To: T10 Technical Committee  
From: William Petty, LSI Logic Corp.  
Subj: **SPI-4 REQ/ACK ISI removal via qualified clocking method**

<u>Rev.</u>	<u>Date</u>	<u>Description of Change</u>
0	9/9/99	Initial Document
<u>1</u>	<u>10/11/1999</u>	<u>Disallowed gating of ST following ST or DT following DT. Paired ST and DT qualification into single event. Revised waveforms to match text.</u>

Figure 1

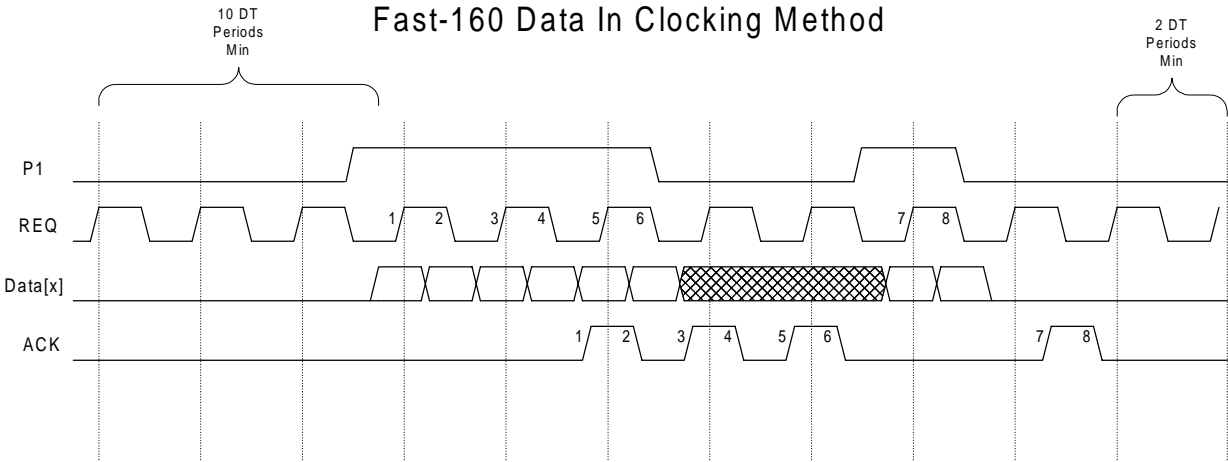
The following graph shows the preferred use of the qualified clocking method. **Note: the P1-gated REQ rising edge may not always be phase aligned with a similar rising edge of ACK. (See transition #6 in Fig 1 below)**
